## GWINNETT COUNTY DEPARTMENT OF FINANCIAL SERVICES PURCHASING DIVISION

April 25, 2024

# Addendum No. 6 BL037-24 Hopkins Mill Subdivision Water Main Replacement

The following addition/changes modify the Bid No. BL037-24 "Hopkins Mill Subdivision Water Main Replacement" Contract Documents, dated March 2024, as first advertised on March 20, 2024.

LONGITUDINAL ROADWAY CUT FINAL BACKFILL

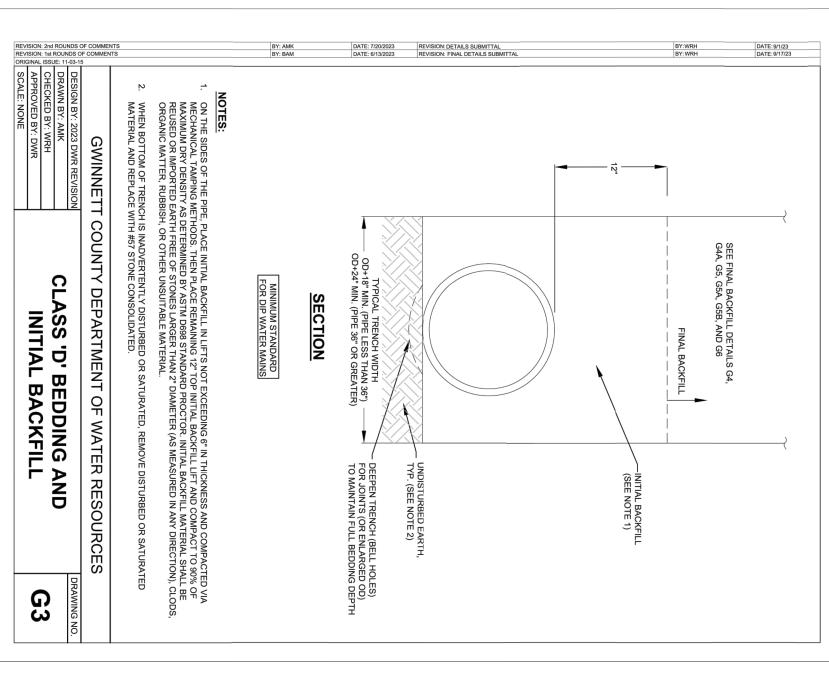
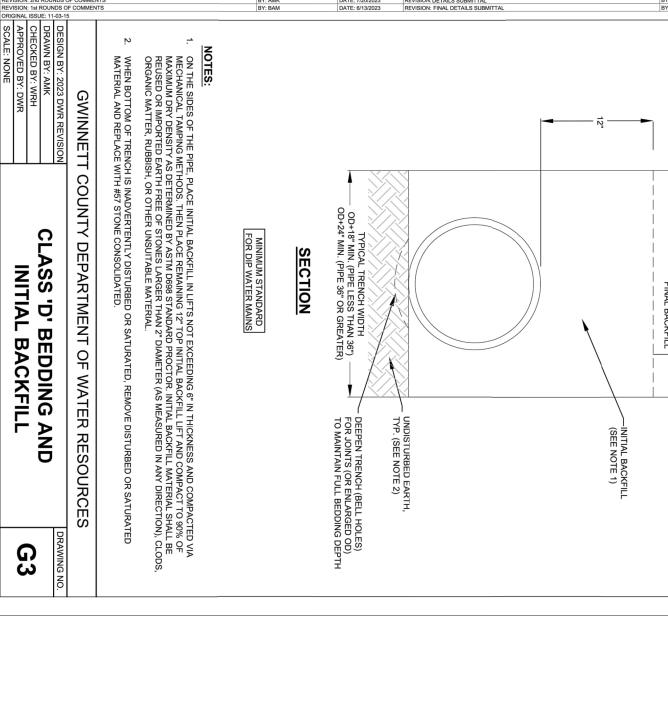
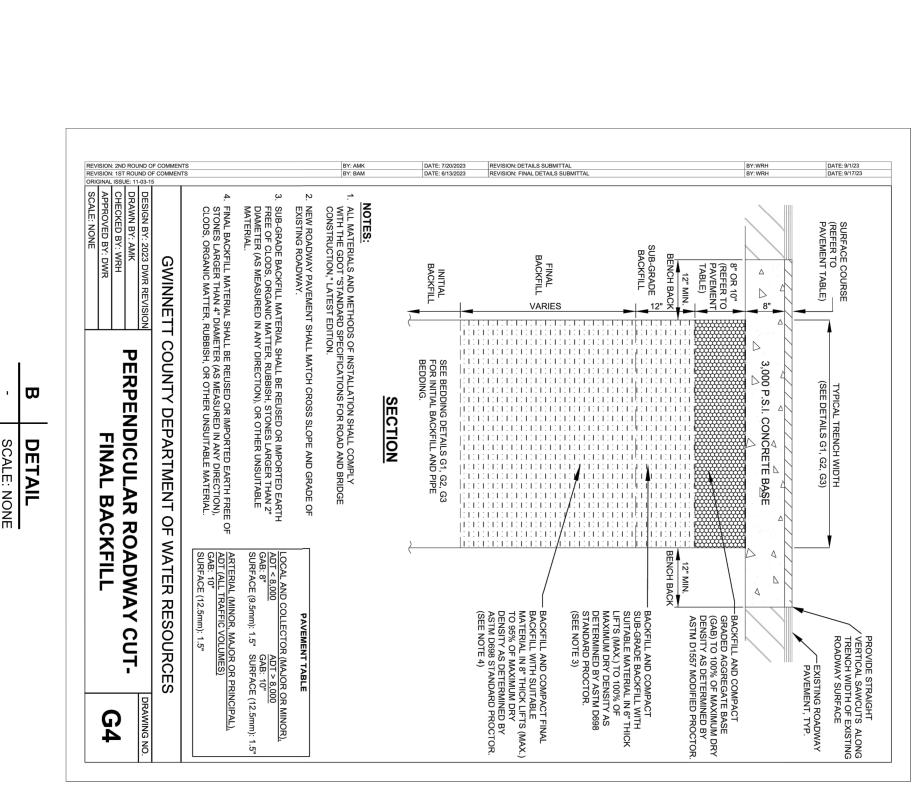
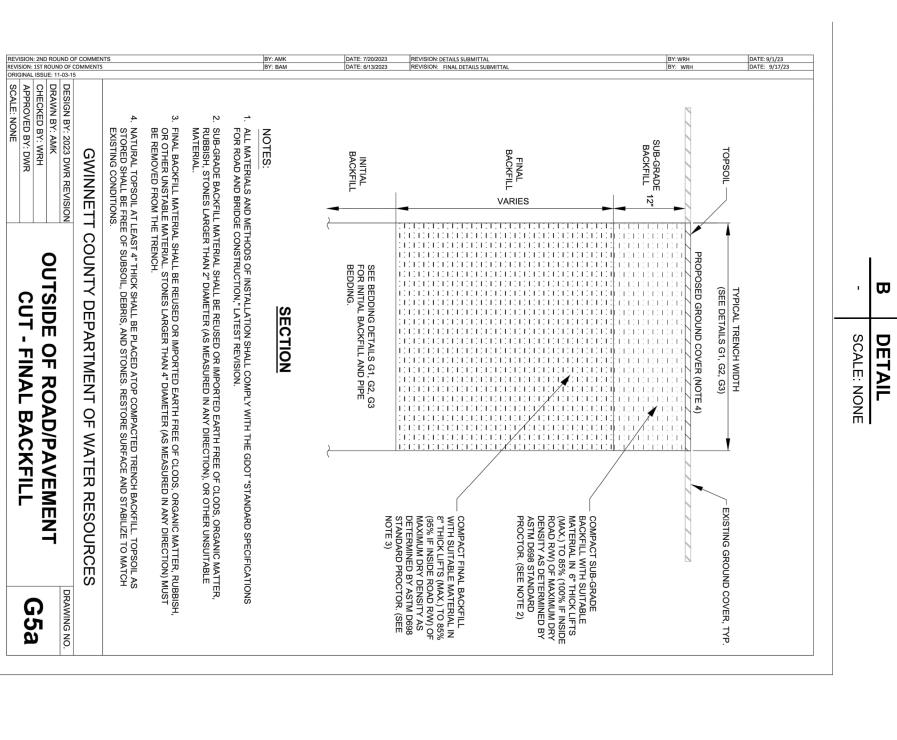
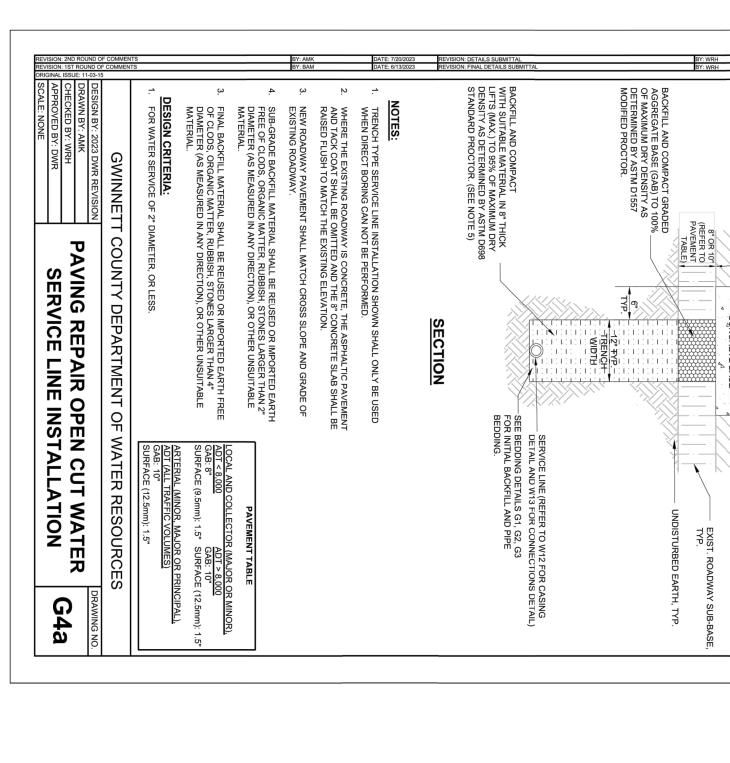
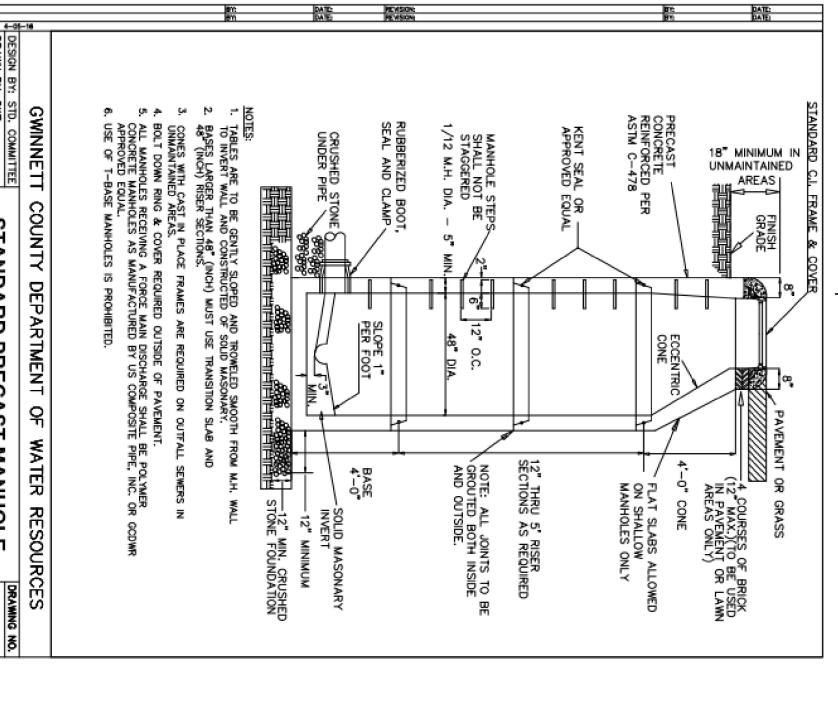
- Q3. Please provide Detail S1 as referred to G-103 / Note #49?
- **A3.** Please see attached Detail S1. CD-001 is revised to include detail S-1. A revised CD-001 is included in this addendum.
